ADDENDUM NO. 1

February 16, 2024

Yorktown High School – Addition and Renovations 1100 South Tiger Drive Yorktown, IN, 47396

ADDENDUM

DRAWING NUMBER **AD201H** PROJECT NUMBER 2022016

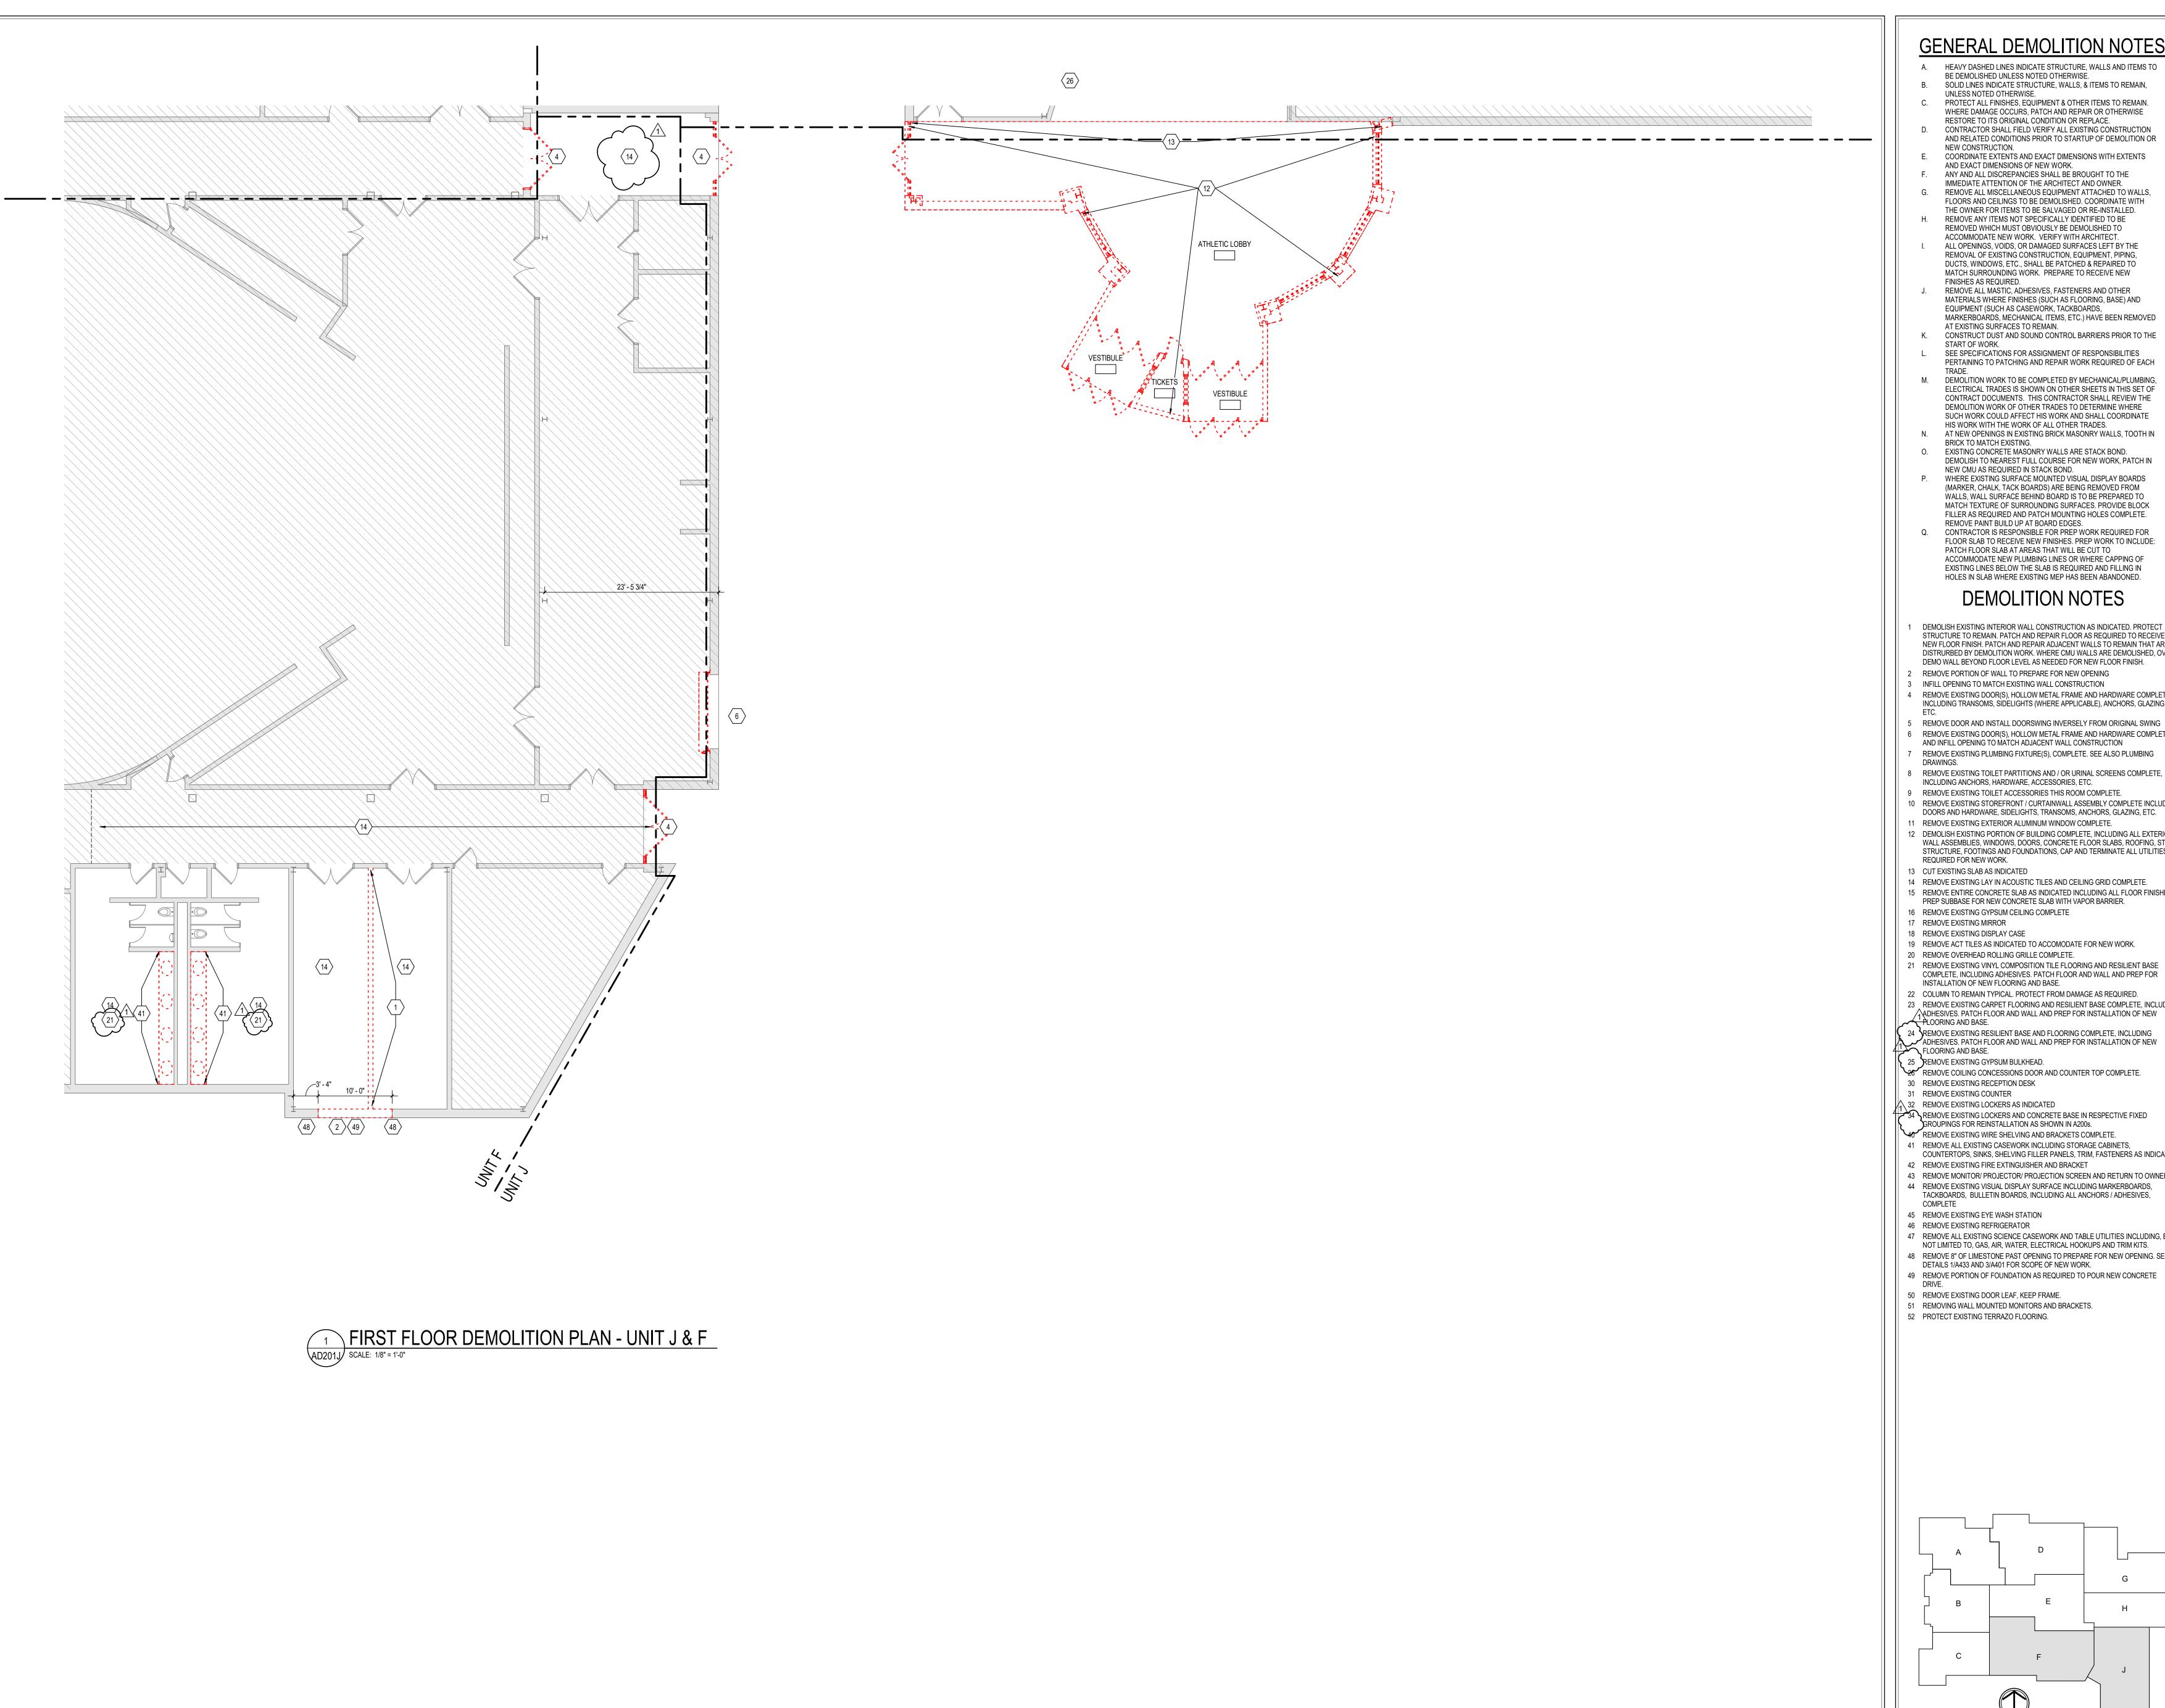
3.5 <u>AD201H – FIRST FLOOR DEMOLITION PLAN – UNIT H</u>

- A. Add Demo Note #14 in Concession.
- B. Add Demo Note #7 for demolition of water fountains.
- C. Add Demo Note #25 REMOVE EXISTING GYPSUM BULKHEAD.
- D. Add Demo Note #26 REMOVE COILING CONCESSIONS DOOR AND COUNTER TOP COMPLETE.

DRAWING TITLE: FIRST FLOOR PLAN - UNIT J &

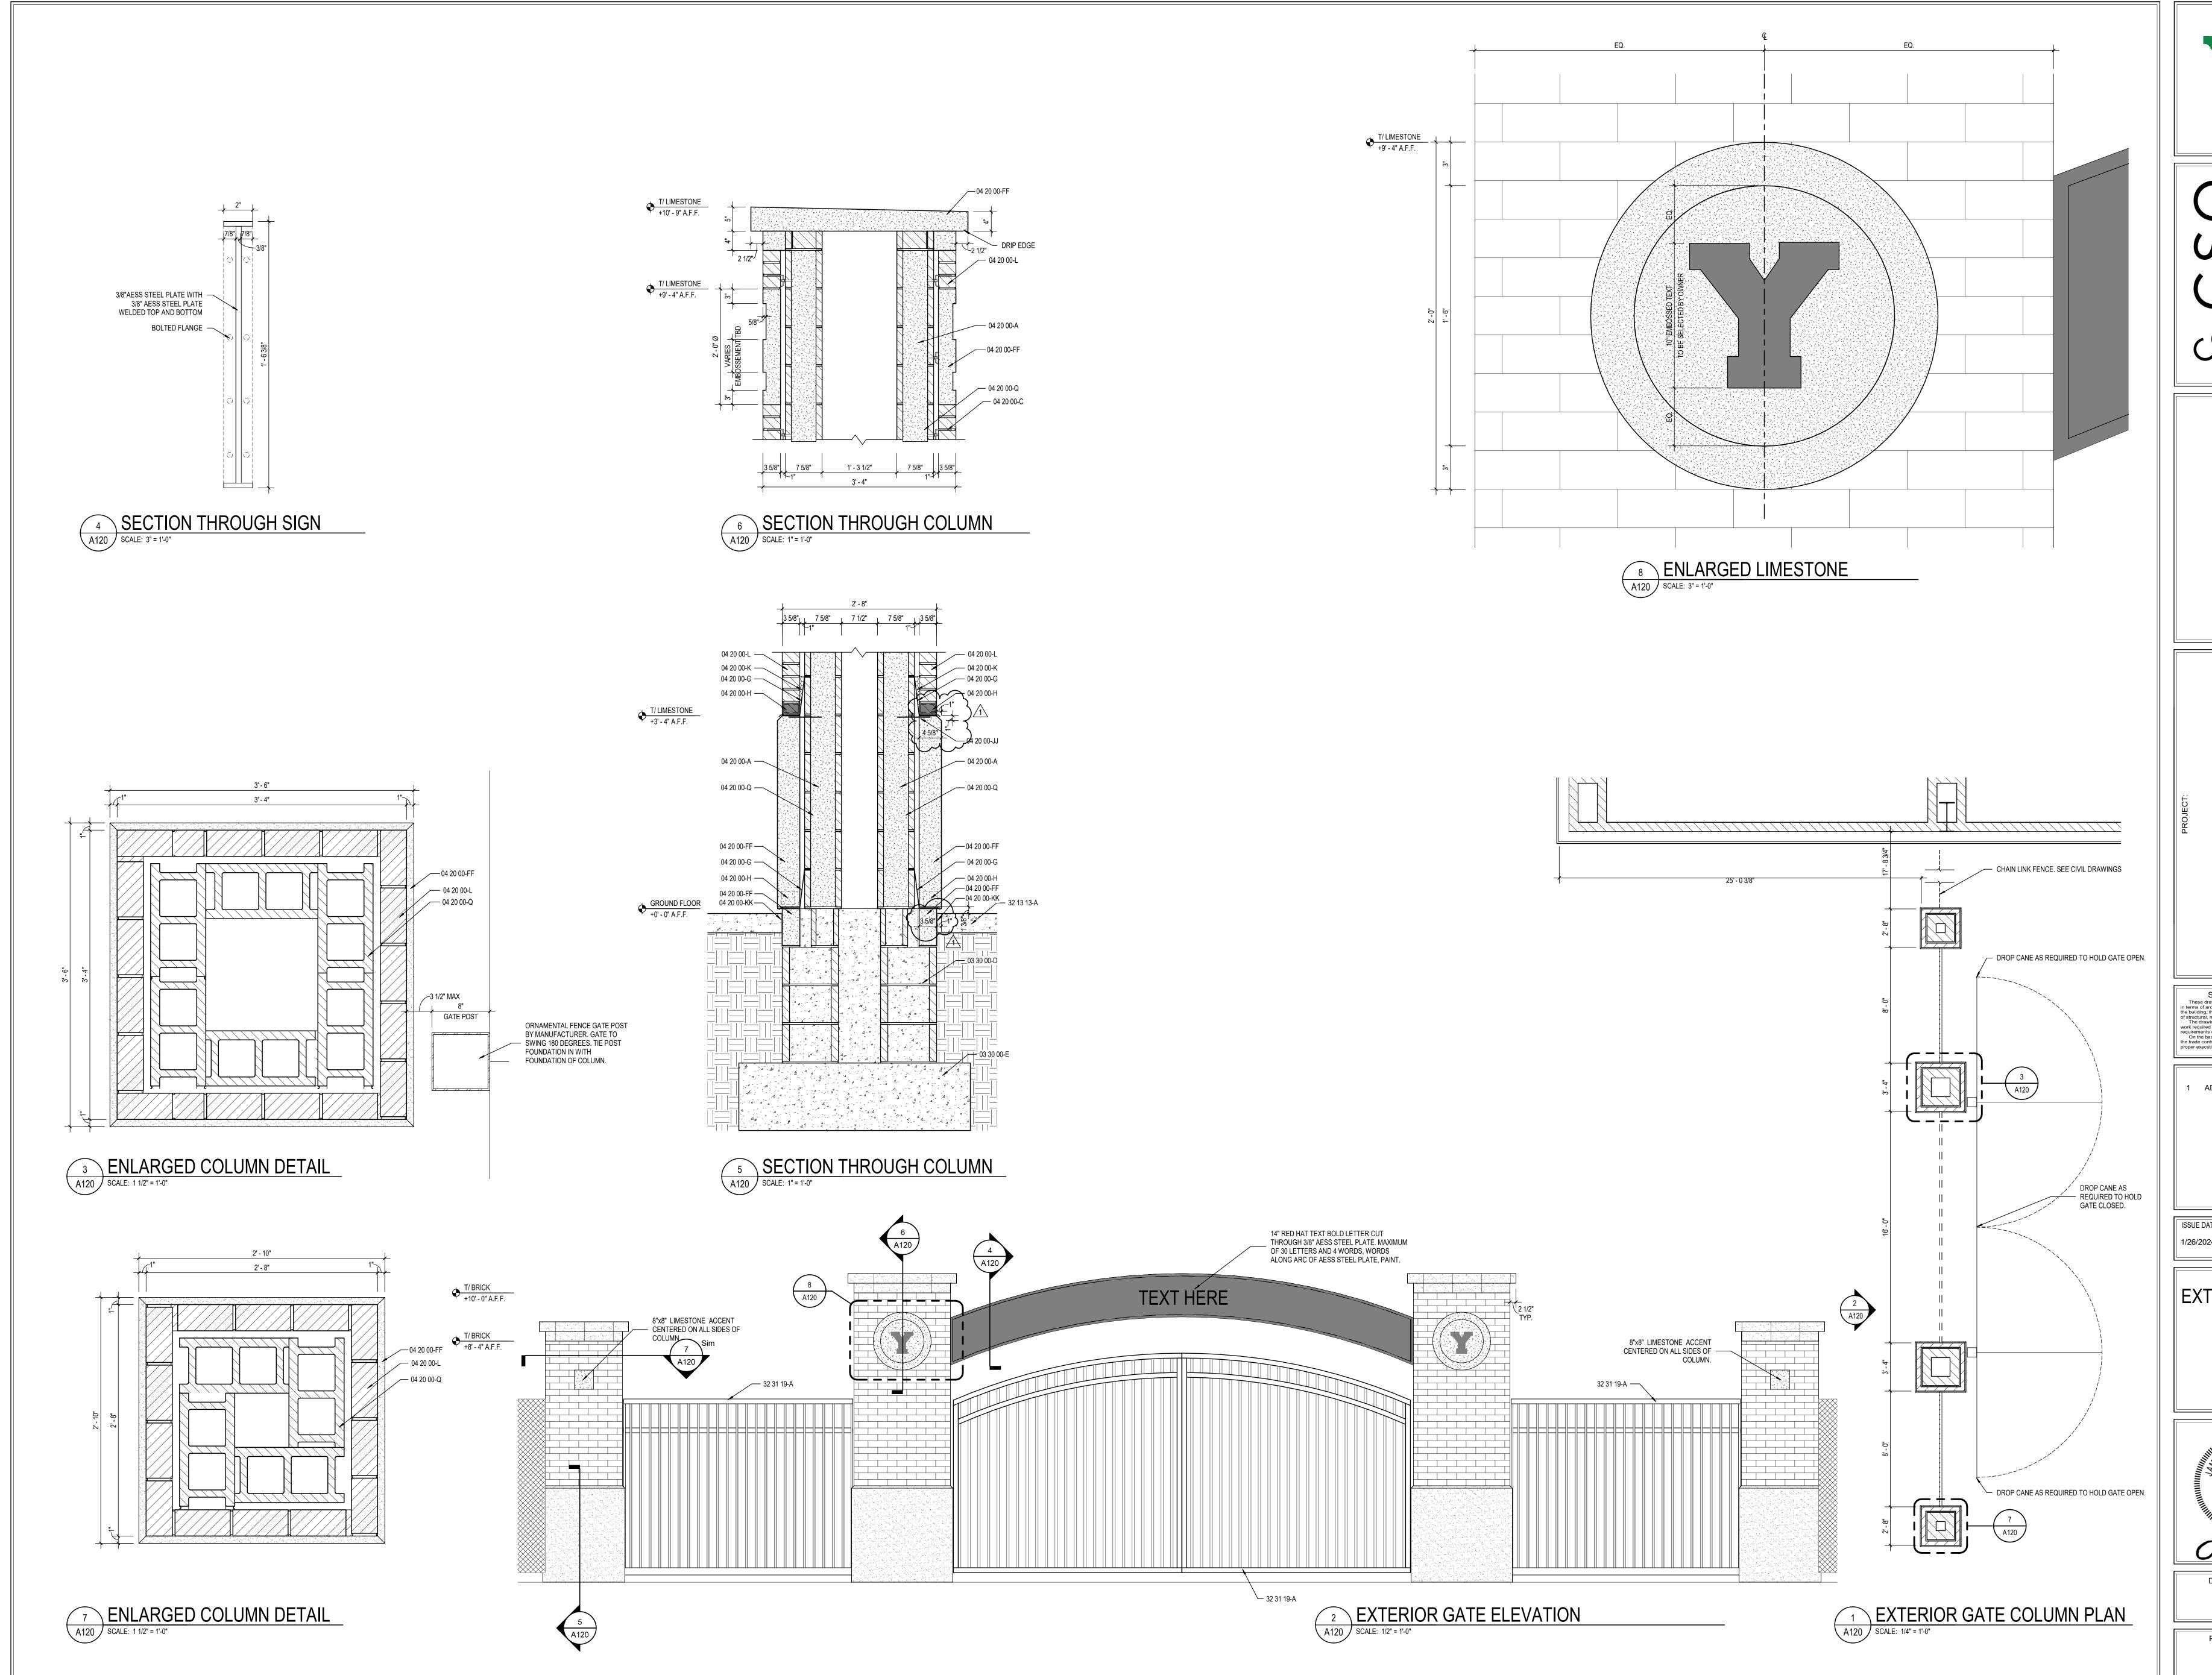
3.6 AD201J – FIRST FLOOR DEMOLITION PLAN – UNIT J

A. Add Demo Note #14 in Vestibule.

B. Add Demo Note #21 in Men's and Women's Restroom.

A201A PROJECT NUMBER

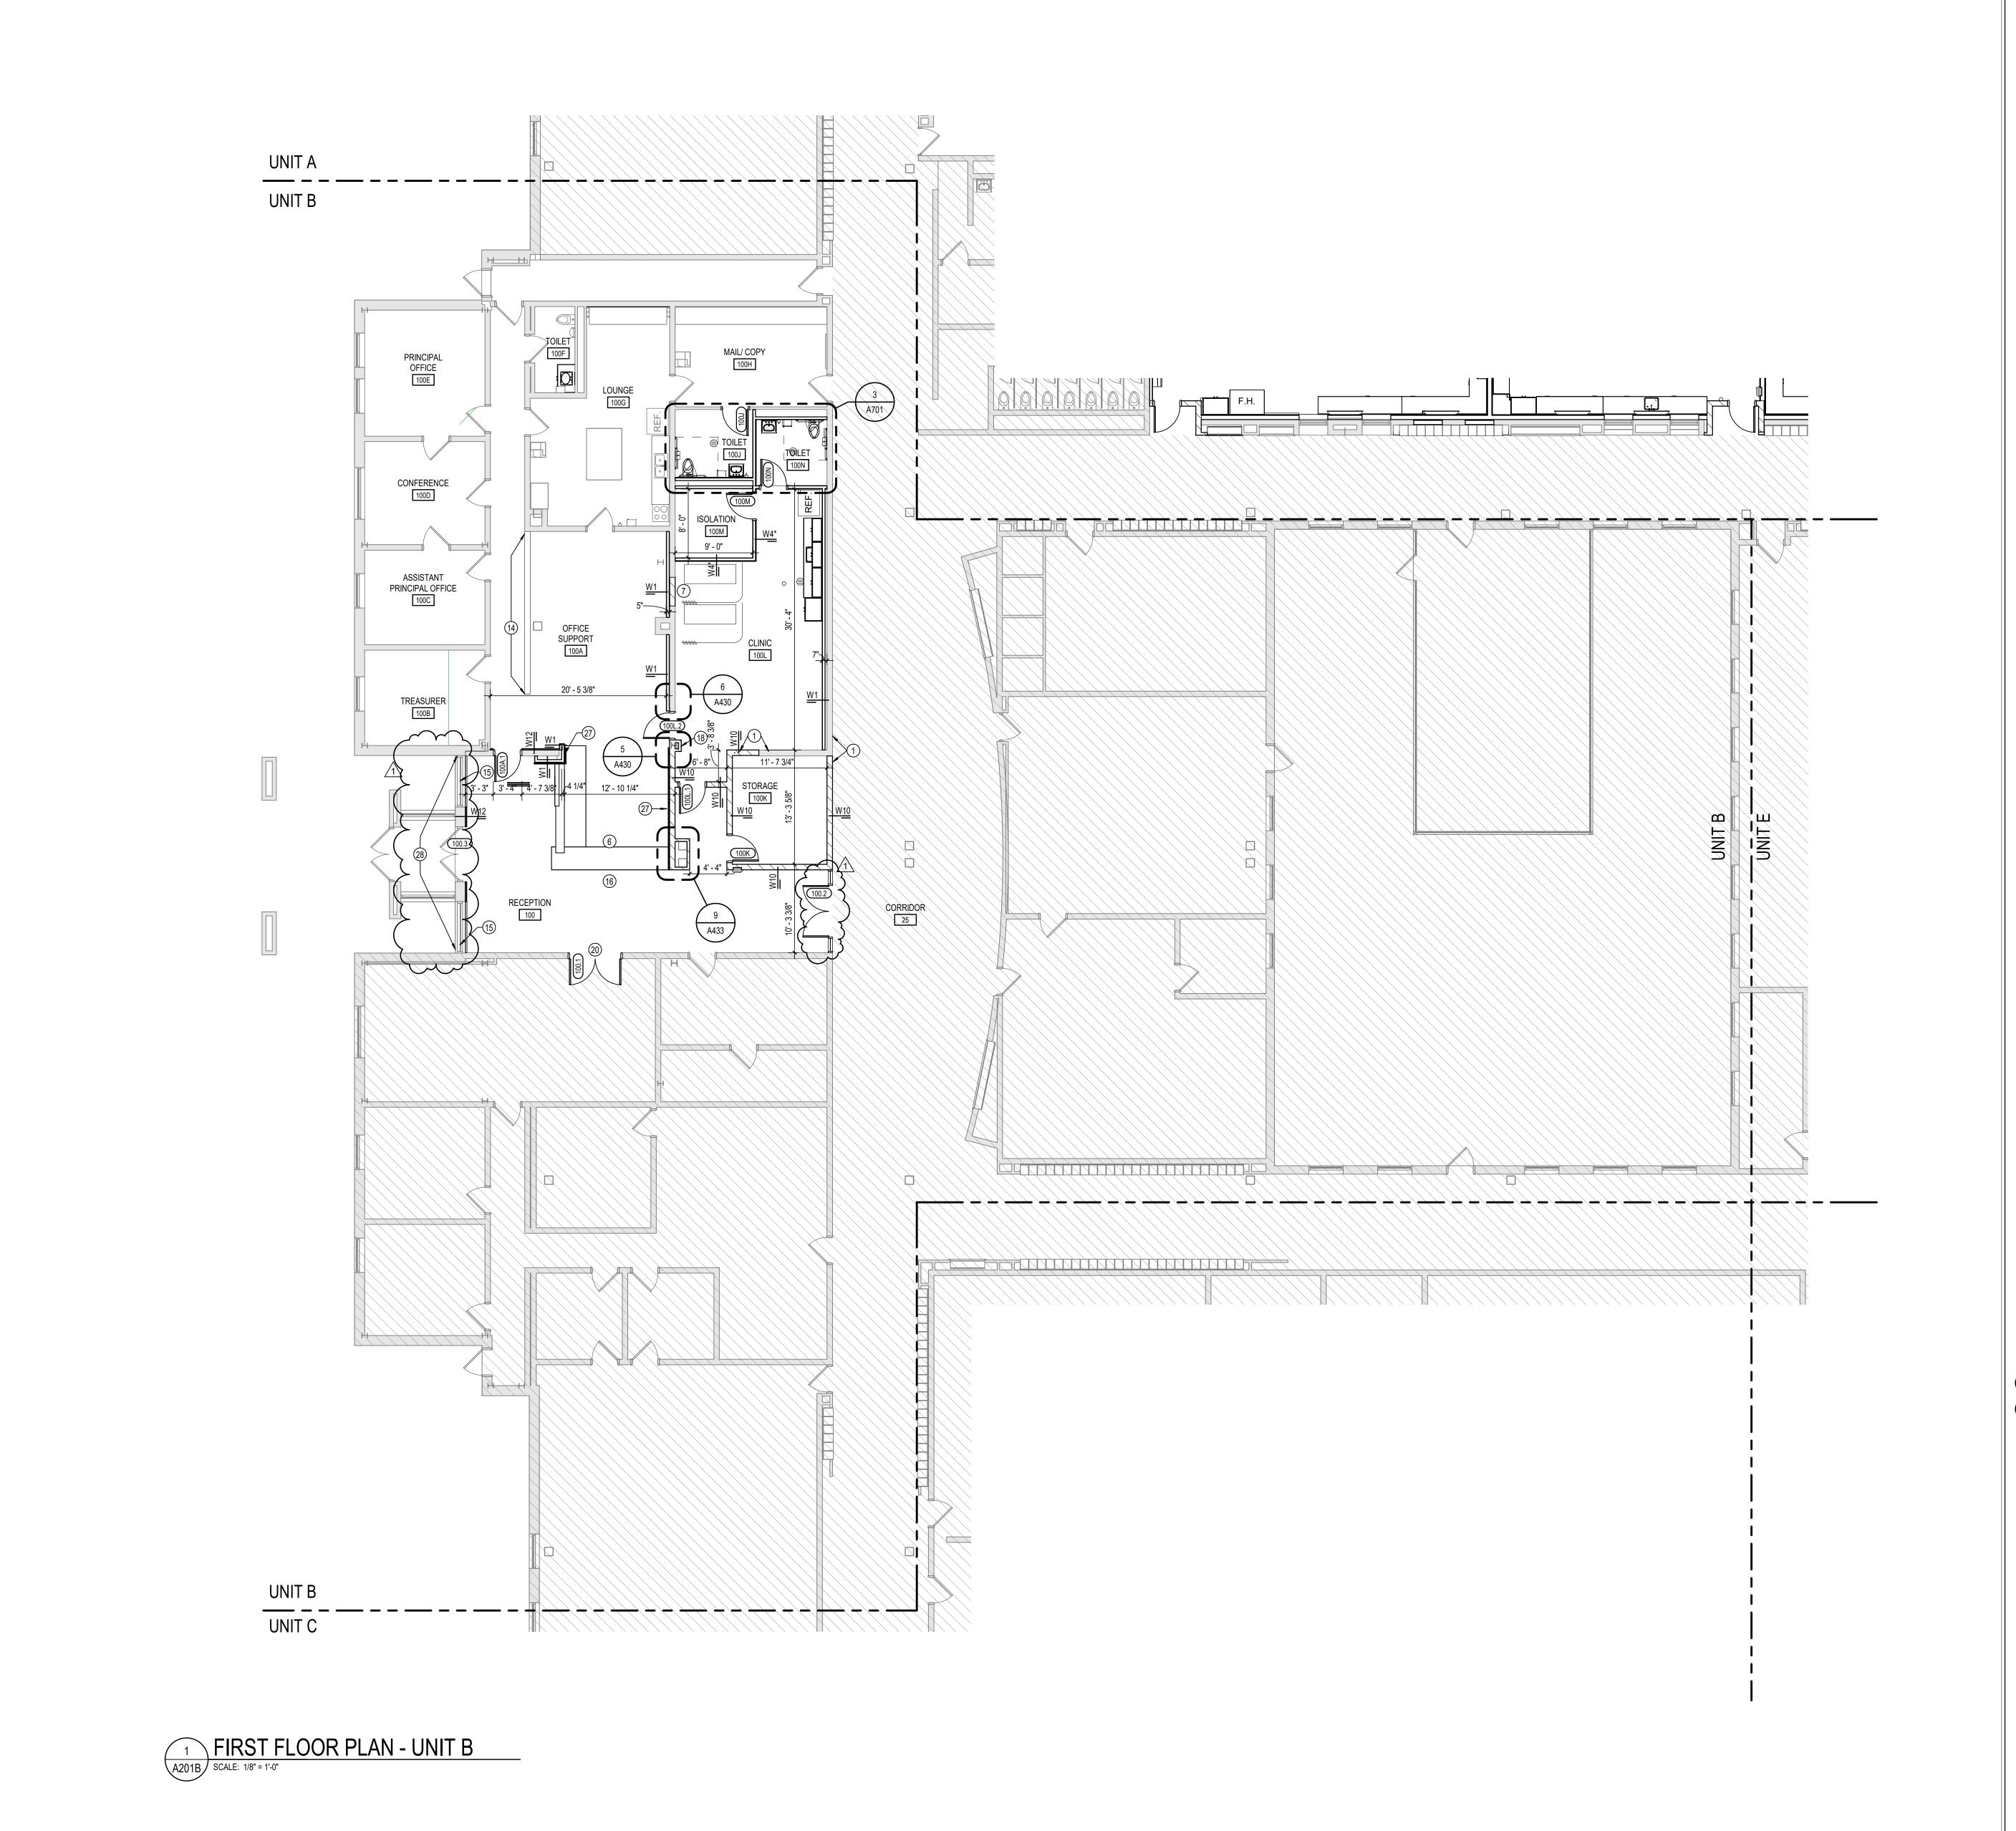
3.9 <u>A201A – FIRST FLOOR PLAN – UNIT A</u>
